Wyman-Gordon's Comments

Nuclear Regulatory Commission Draft Dose Assessment

May 14, 1993

Prepared by
Bechtel Environmental, Inc.

Figure 1

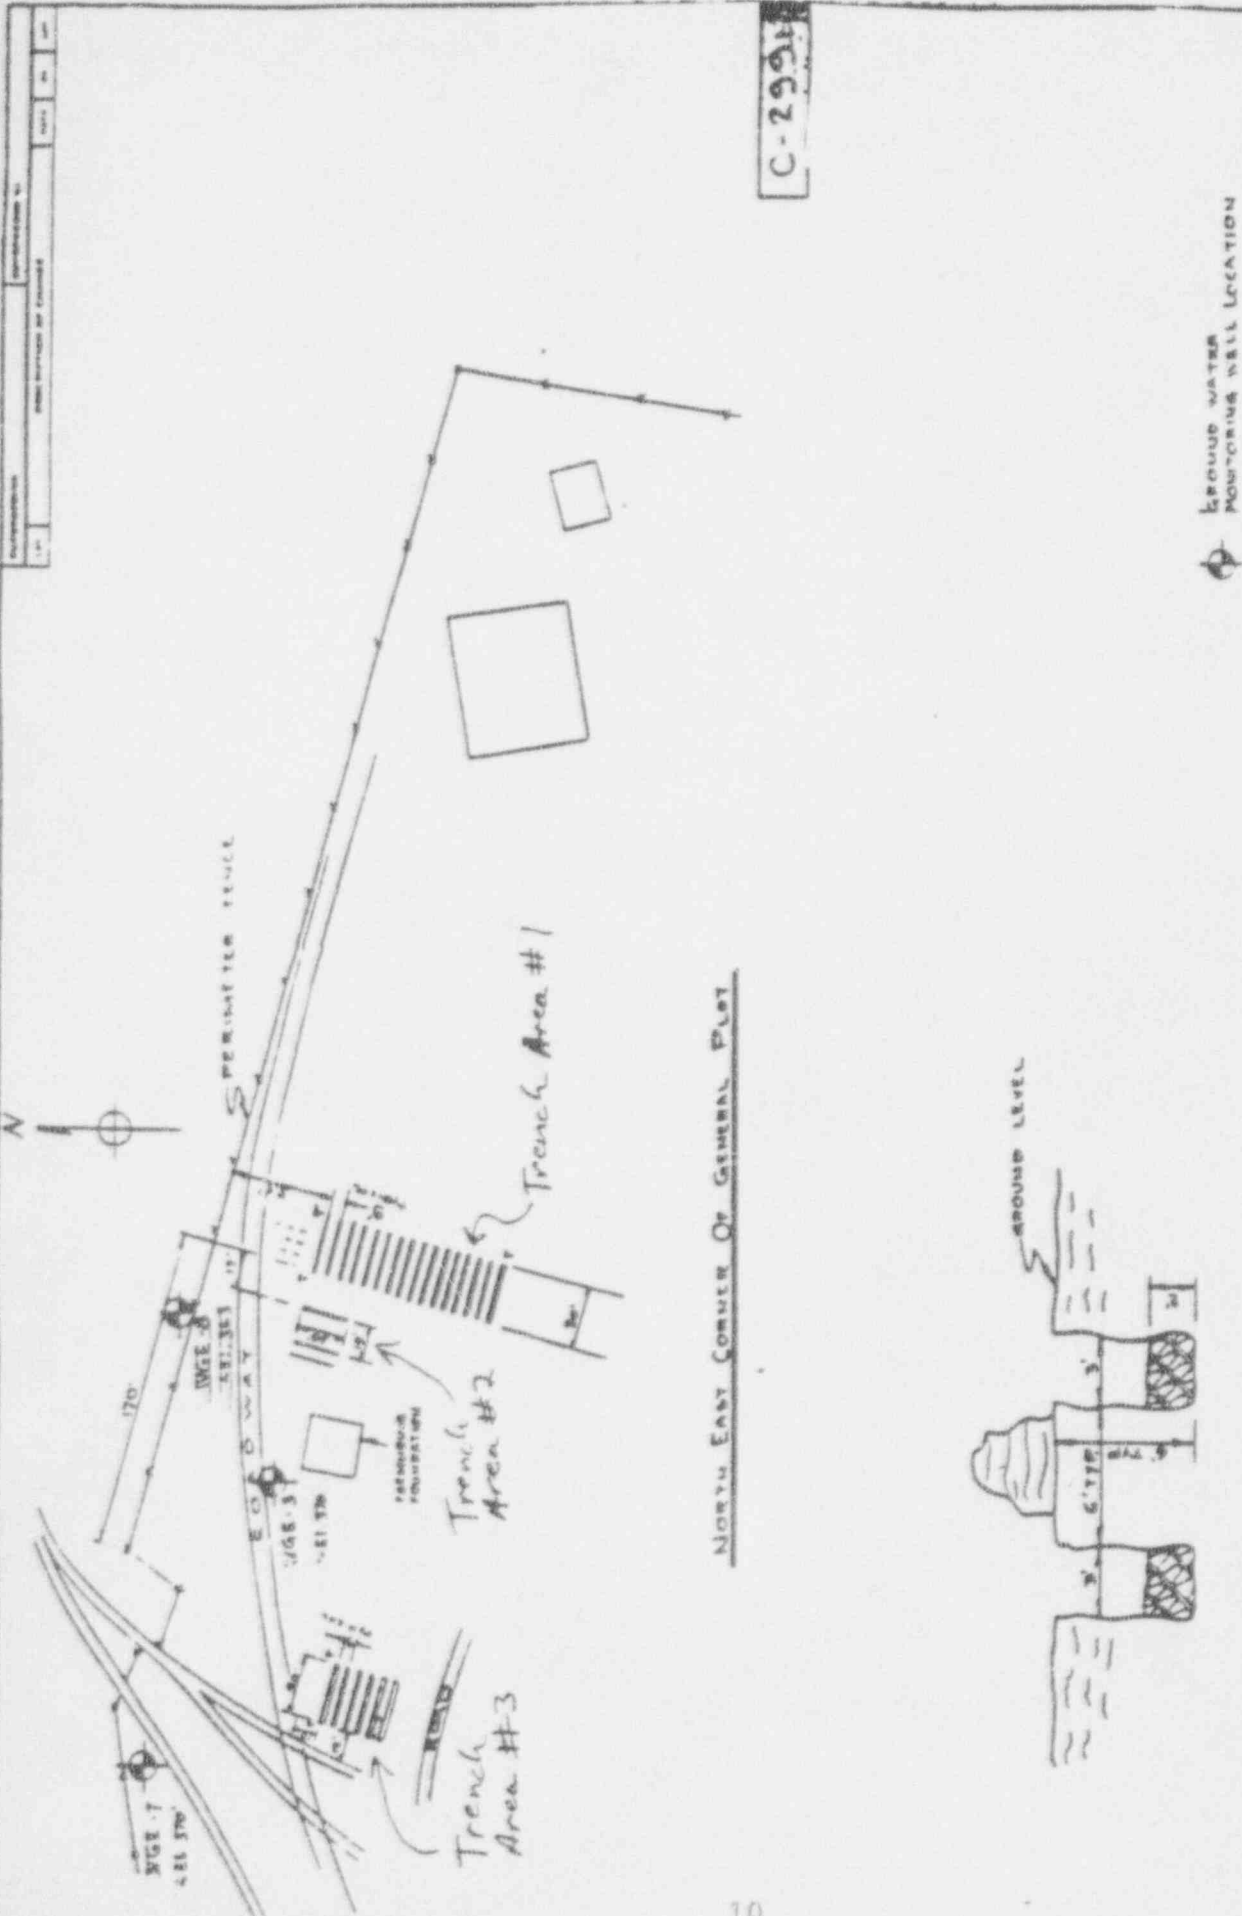
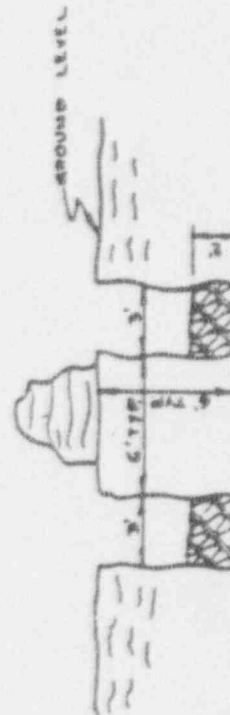
The trenches in the PNL dose assessment were described as being 30 feet long, 3 feet wide and 2 feet deep, with no surface cover. However, there are 4 feet of surface cover on the trenches. As stated in the "Site Decommissioning Management Plan" (NRC 1992a), "The magnesium-thorium wastes are buried and covered by 4 feet of soil." The fact that there are 4 feet of soil covering the waste is further supported by: a) a series of as-built drawings (Wyman-Gordon 1961, 1970) on trench details (see Figure 1); b) a letter on "Information Regarding Mag-Thorium Low-Level Radioactive Wastes Buried at Wyman-Gordon Company, 244 Worcester Street, North Grafton, MA" (Wyman-Gordon 1991); and c) the "Summary of Data Investigation of the Magnesium-Thorium Disposal Area" (GZA 1991).

Specifically, the trench detail shown in Figure 1 indicates that each of the trenches is 6 feet deep with 2 feet of magnesium-thorium waste material at the bottom of the trench and 4 feet of surface cover on top of the waste.
